May 5, 2016

RE: Hillsdale Terrace

28th Avenue corner plaza accommodate few tables and does not have a very open and inviting look

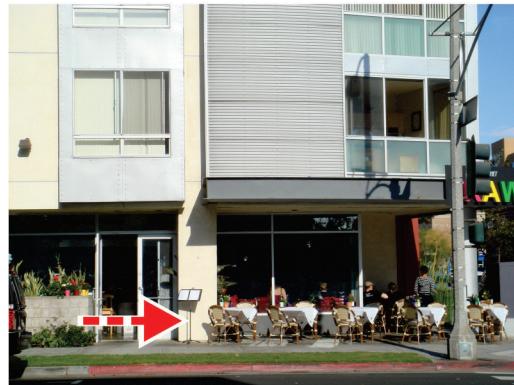
The corner at El Camino Real and 28th Avenue will be a strong focal point by virtue of the future extension of 28th Avenue to Bay Meadows II. Yet, the Public Corner Space as currently shown appears to accommodate very few tables if it were to be used as an outdoor dining terrace. And the walls and planters at the edges of the space does not give the area an open and inviting public appearance - see the illustrations below.

Recommendation: Modify the edge design of both the 28th and 27th Avenue Public Open Spaces to provide a more open and inviting feeling- see example photos below.

2. Public Art

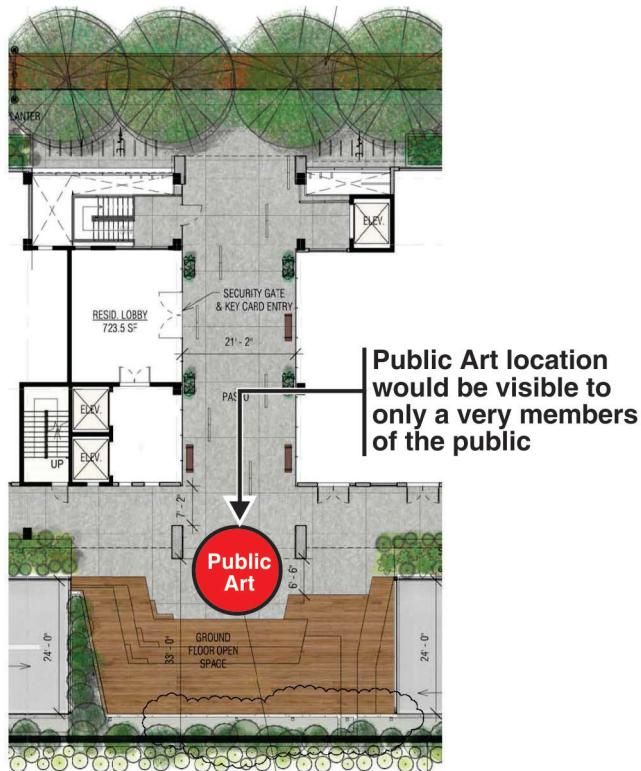
A public art piece is shown located at the rear of the property adjacent to the proposed ground floor open space. In that location, it would be seen by only a small number of the public.

Recommendation: Consider moving the public art piece to a more publicly visible location.

3. Potential Sound Impact

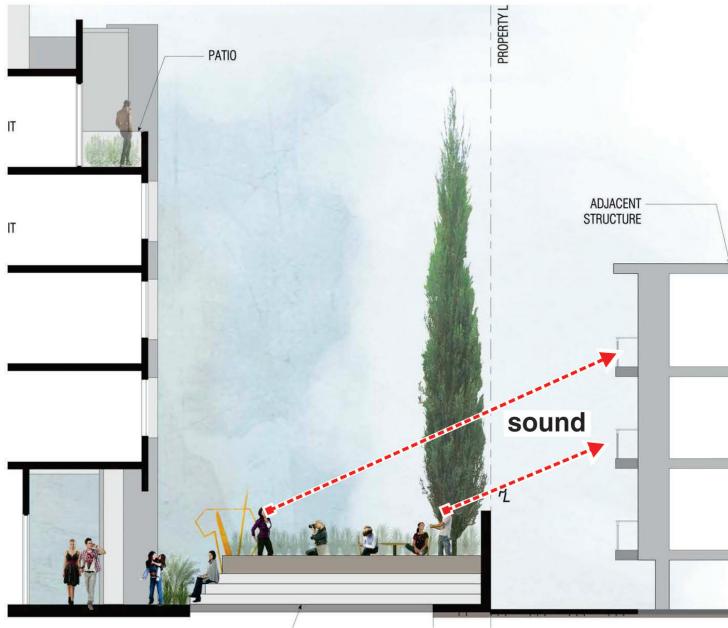
There is a ground floor open space proposed at the rear of the site. The design, as currently shown, would construct an elevated platform with stepped seating to accommodate several tables and chairs as a significant gathering space. It is unknown how much use this space might be used in the evening since residents of the building also have access to a rooftop deck. However, any substantial activity here could have an impact on the residential units in the adjacent apartment building with frontage on this site.

Recommendation: Staff should discuss the use and design of this open space to minimize any potential sound impacts.
